**Project Name: UNIVERSITY OF CALIFORNIA, MERCED
CLASSROOM AND OFFICE BUILDING 1 RENOVATION**

Project No.: 908078

ADDENDUM NO. 1
to the
CONTRACT DOCUMENTS
March 18, 2020

Sheet Number: **E3.02A**

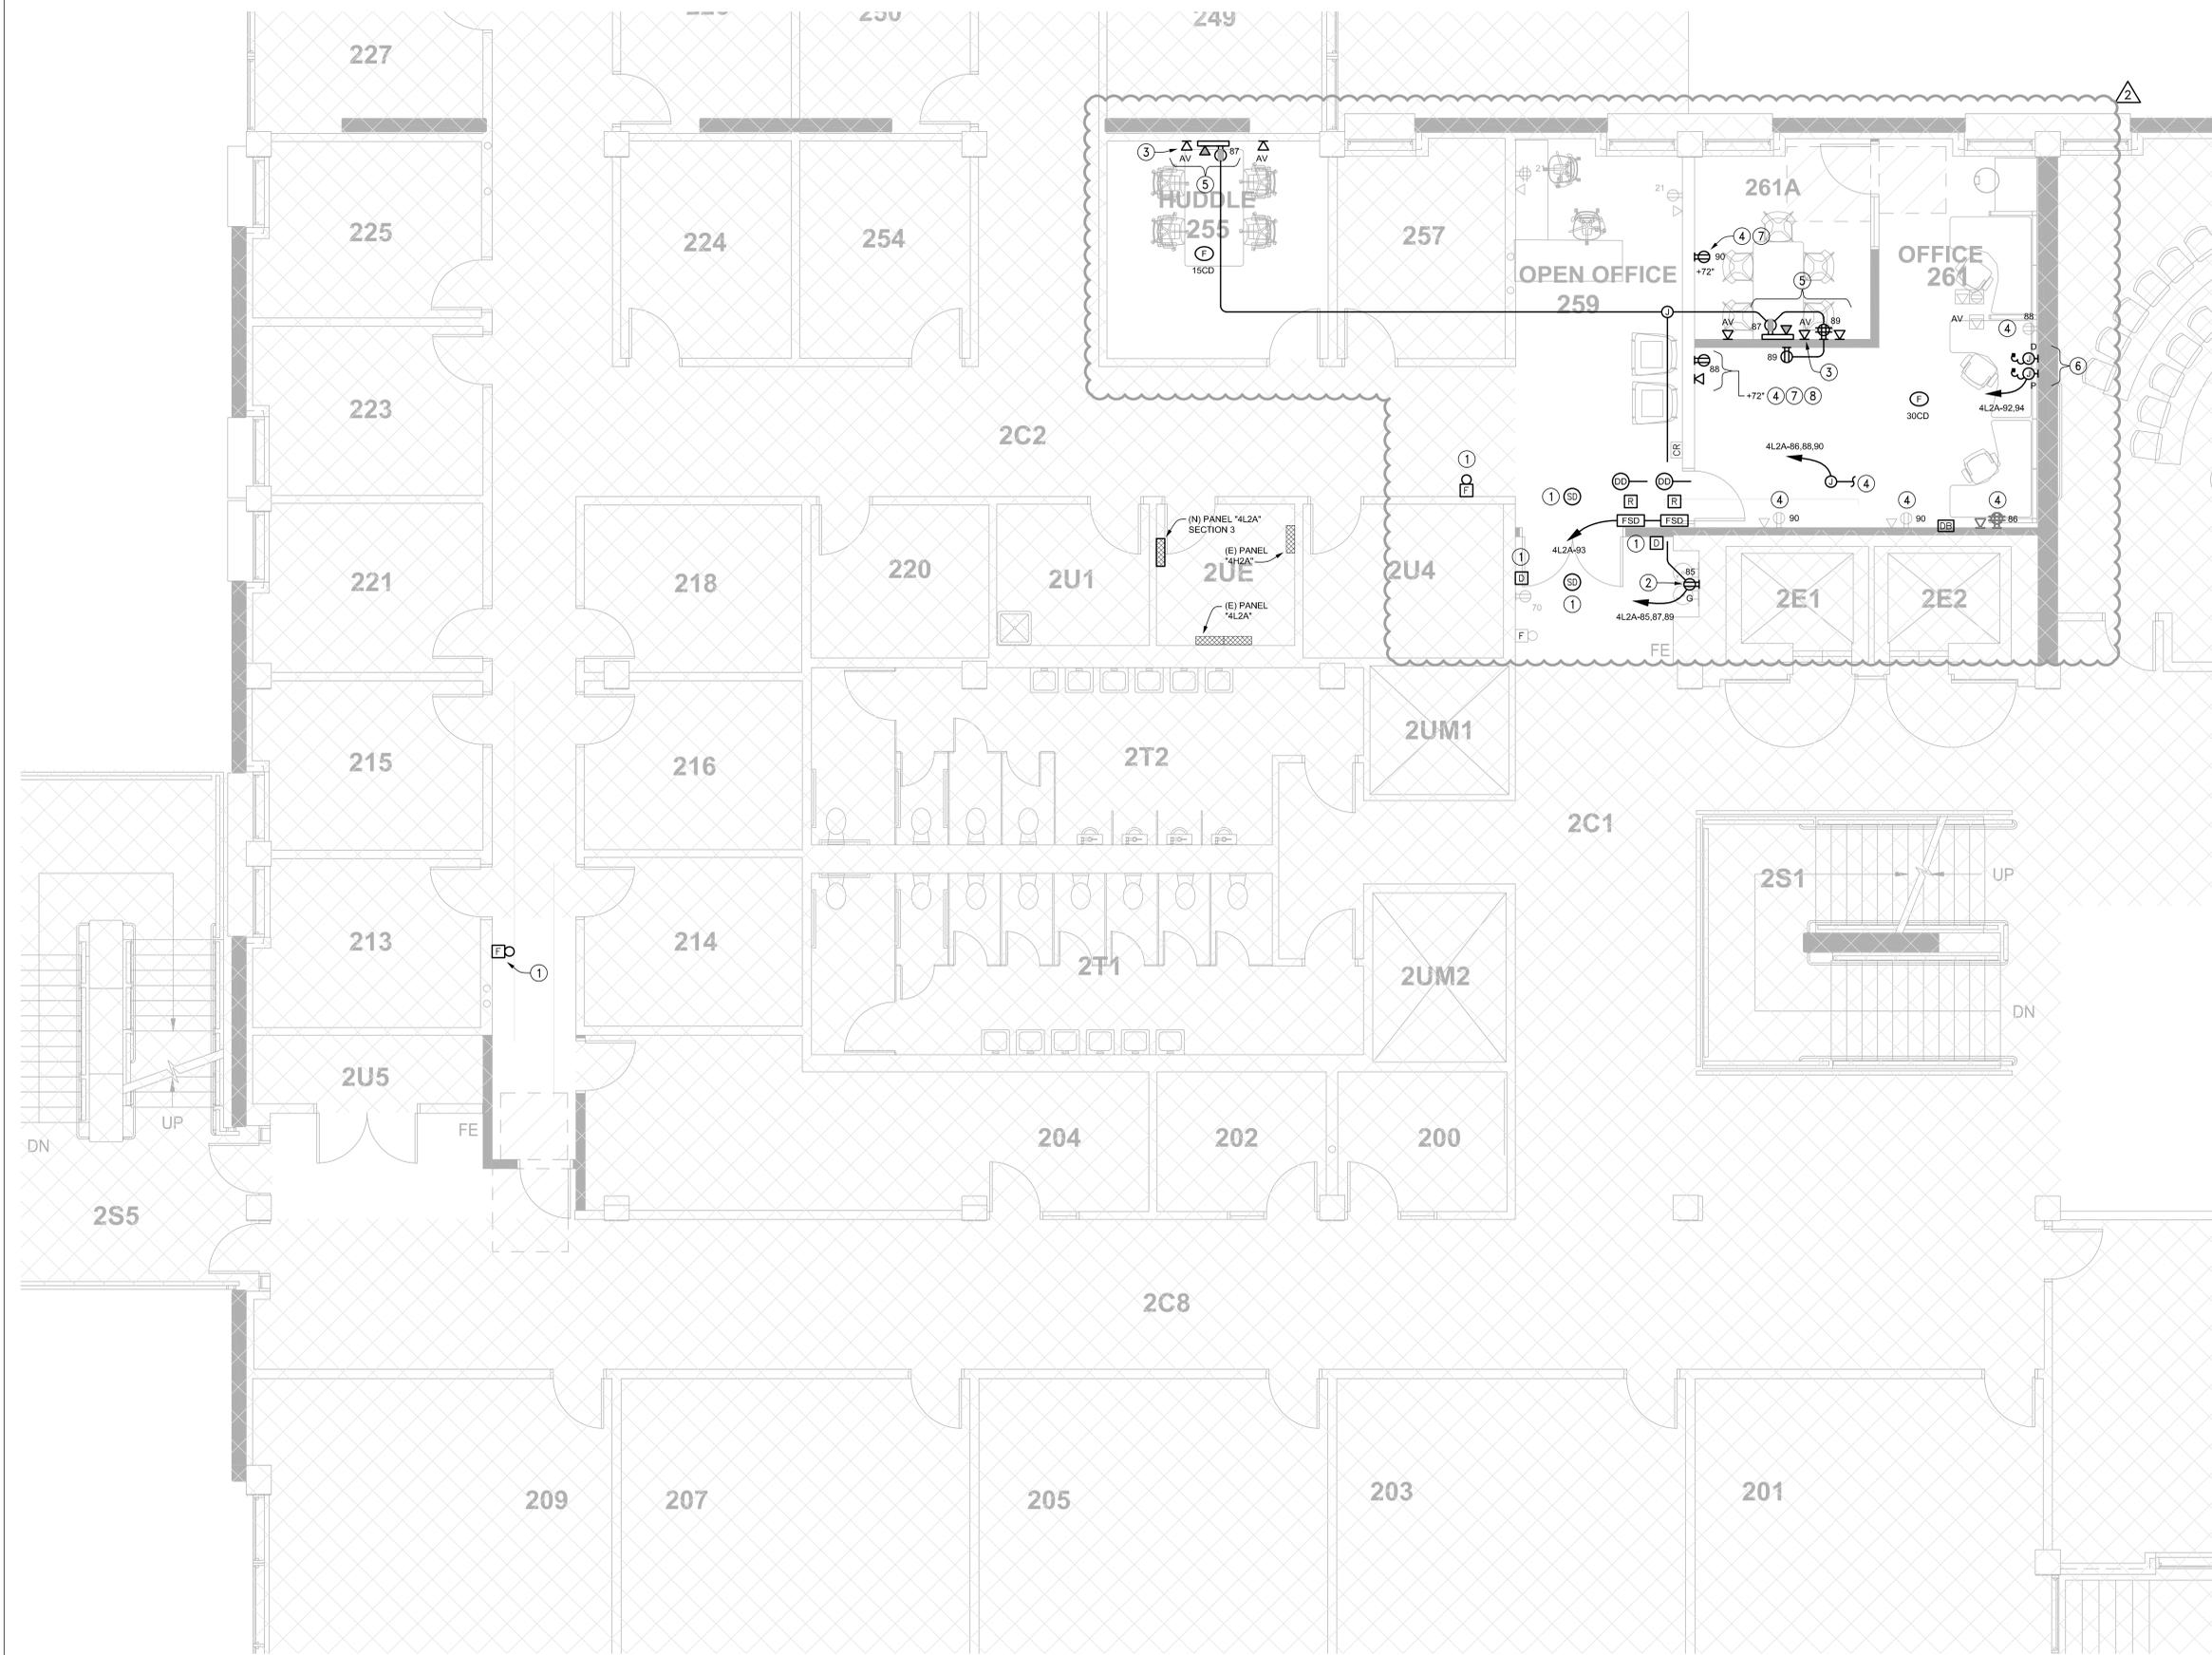
E3.01C	FIRST FLOOR AREA C NEW POWER & SIGNAL PLAN	1. Deleted work at drinking fountain. 2. Updated sheet notes.
E3.02A	SECOND FLOOR AREA A NEW POWER & SIGNAL PLAN	1. Revised Sheet Notes No.2.
<u>E3.02B</u>	<u>SECOND FLOOR AREA B NEW POWER & SIGNAL PLAN</u>	<u>1. Added new work.</u>
E3.02C	SECOND FLOOR AREA C NEW POWER & SIGNAL PLAN	1. Revised work per new space layout. 2. Revised sheet notes.
E3.02D	SECOND FLOOR AREA D NEW POWER & SIGNAL PLAN	1. Revised work per new space layout. 2. Revised sheet notes.
E3.03A	THIRD FLOOR AREA A NEW POWER & SIGNAL PLAN	1. Deleted ceiling mounted WAP outlets and added wall mounted WAP outlet. 2. Deleted new floor mounted poke-thru devices. 3. Revised work at existing flush mounted floor boxes. 4. Added empty conduit pathway in ceiling space. 5. Revised work at ""FSR"" A/V boxes. 6. Revised sheet notes.
E3.03B	THIRD FLOOR AREA B NEW POWER & SIGNAL PLAN	1. Relocated ceiling mounted WAP outlet in room 380. 2. Added ceiling mounted WAP outlet in Colloquy and Break Room. 3. Added wall mounted WAP outlets in open office. 4. Deleted new floor mounted poke-thru devices. 5. Revised work at existing flush mounted floor boxes. 6. Added empty conduit pathway in ceiling space. 7. Revised work at ""FSR"" A/V box. 8. Added ""FSR"" A/V box in Colloquy. 9. Revised circuiting in Break Room. 10. Revised sheet notes.
